SUBDIVISION COMMITTEE  
METROPOLITAN AREA PLANNING COMMISSION

STAFF REPORT:  
(One-Step Final Plat)

CASE NUMBER: SUB 2006-15 -- DATER ADDITION

VICINITY MAP

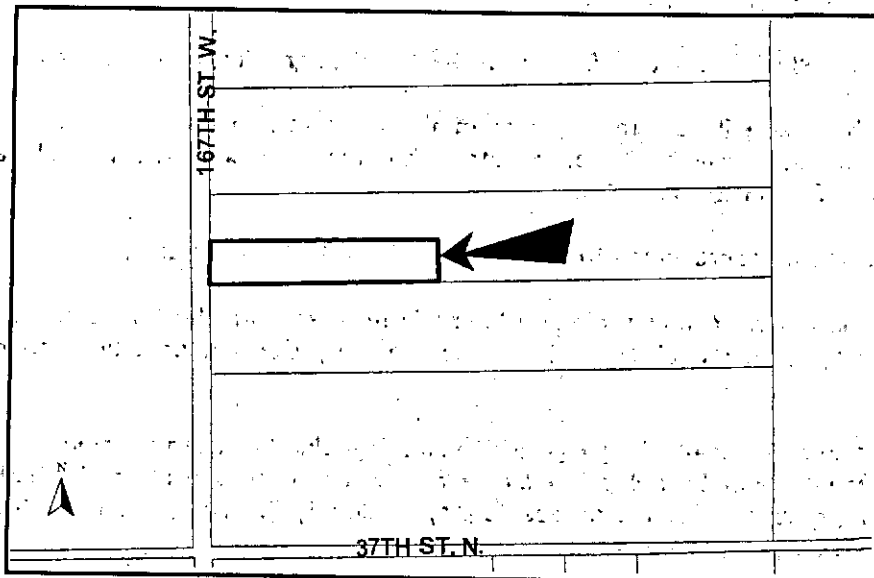
**NOTE:** This is unplatted property located in the County within three miles of the City of Wichita. It is in an area designated as "2030 Urban growth area" by the Wichita-Sedgwick County Comprehensive Plan. It is located in the Colwich Area of Influence.
